**Economic and Social Council**Distr.: General
22 July 2011Original: English
English and French only

World Forum for Harmonization of Vehicle Regulations**Working Party on Lighting and Light-Signalling****Sixty-sixth session**

Collective amendments - Regulations Nos. 23 and 48**Proposal for a new series of amendments to
Regulation No. 48 (Installation of lighting and light-signalling
devices)****Submitted by the Chair of the task force on courtesy lamp of the
Working Party on Lighting and Light-Signalling ***

Observing area towards the apparent surface of manoeuvring lamps

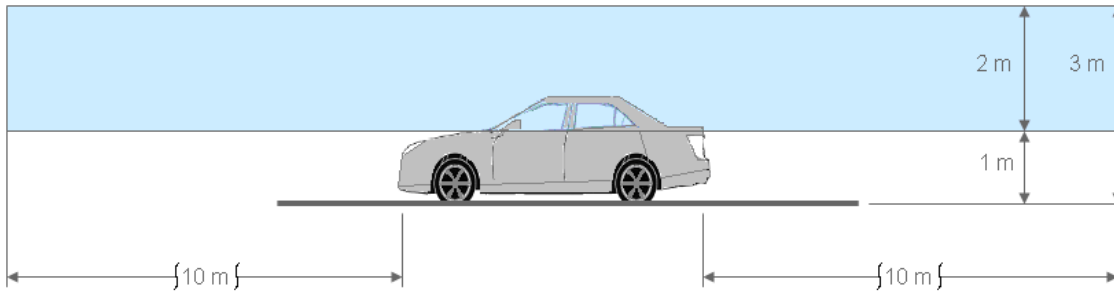
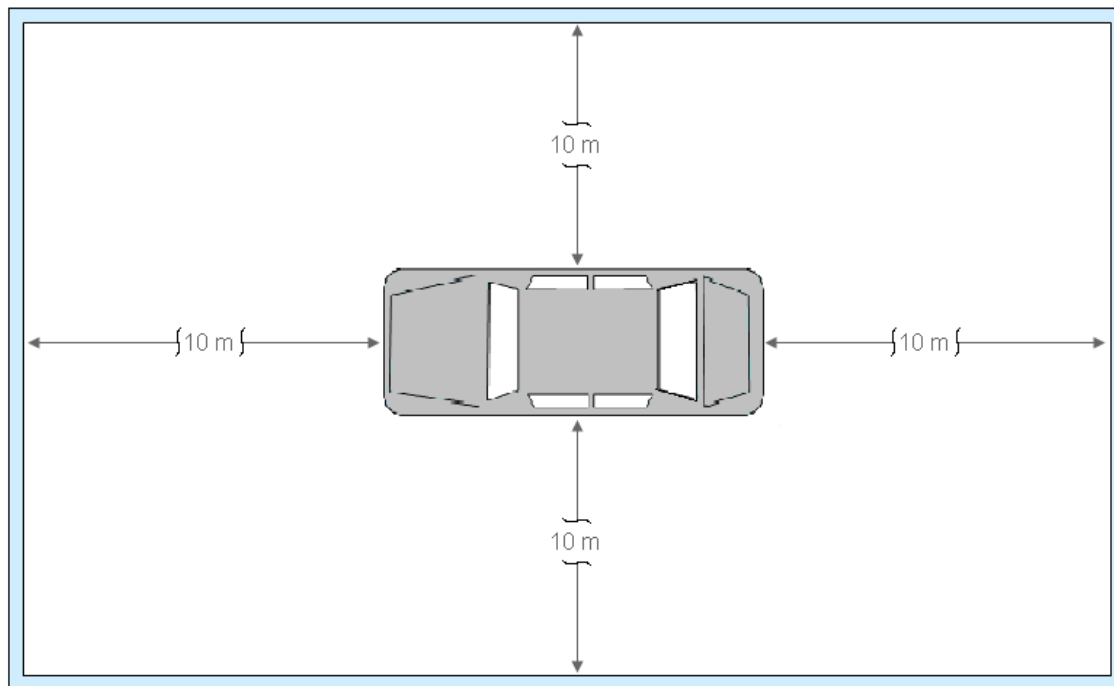
Insert a new Annex 13, to read:

This drawing shows the zone from one side, the other zones are from the front, the rear and from the other side of the vehicle

- 6.26.8. **Tell-tale**
No special requirement.
- 6.26.9. **Other requirements**
- 6.26.9.1. **The Technical Service shall, to the satisfaction of the authority responsible for type-approval, perform a visual test to verify that there is no direct visibility of the apparent surface of these lamps, if viewed by an observer moving on the boundary of a zone on a transverse plane 10 m from the front of the vehicle, a transverse plane 10 m from the rear of the vehicle, and two longitudinal planes 10 m from each side of the vehicle; these four planes to extend from 1 m to 3 m above and parallel to the ground as shown in Annex 13.**
